This project is exempt from ESC Plan Review Date 7-2-2003 Lake SWCD

Grading Plan Approved as shown and/or noted JAMES R. GILLS, P.E. Lake County Engineer

SITE PLAN FOR CEDARCRAFT LOG HOMES
CONVOCED TOWNSHIP LAKE COUNTY STATE OF OHIO

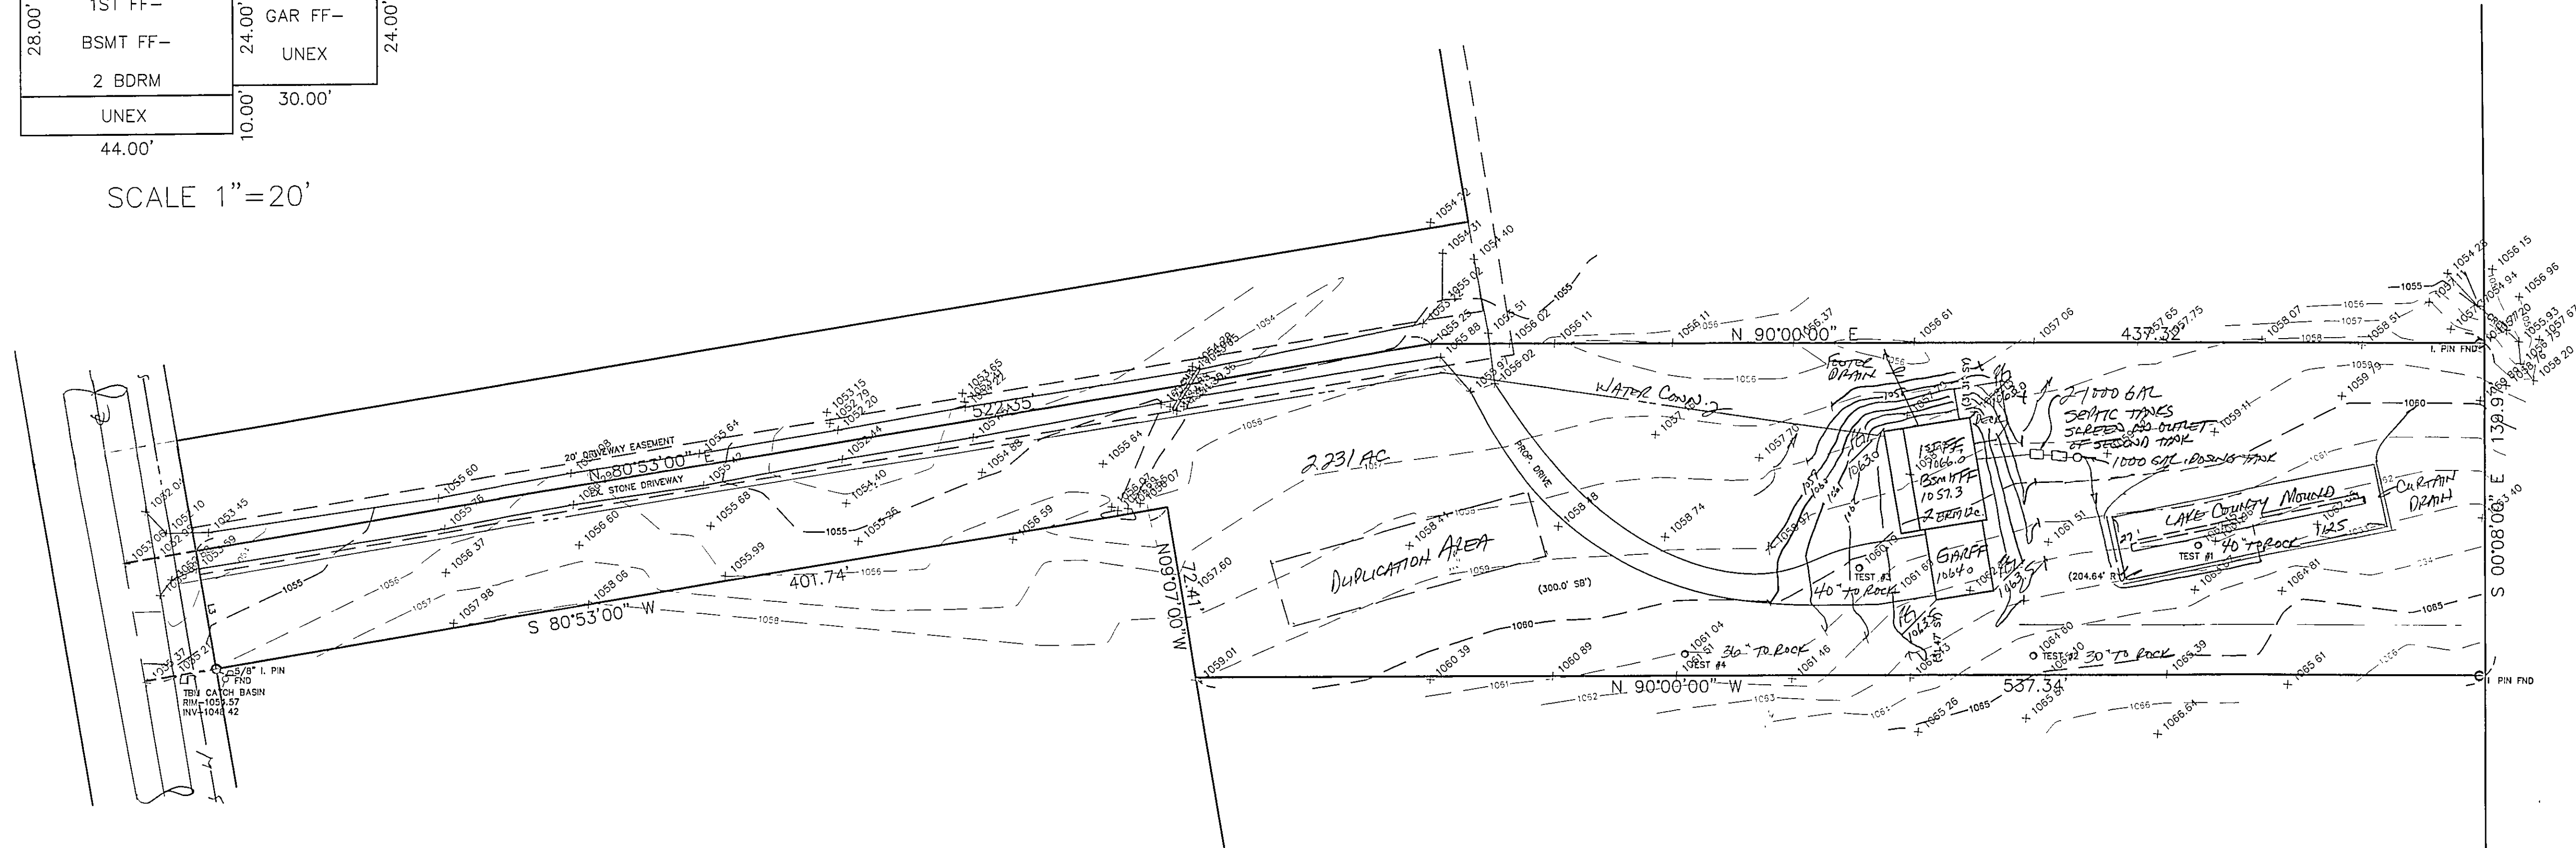
Discharge Footer Drain to defined drainage channel
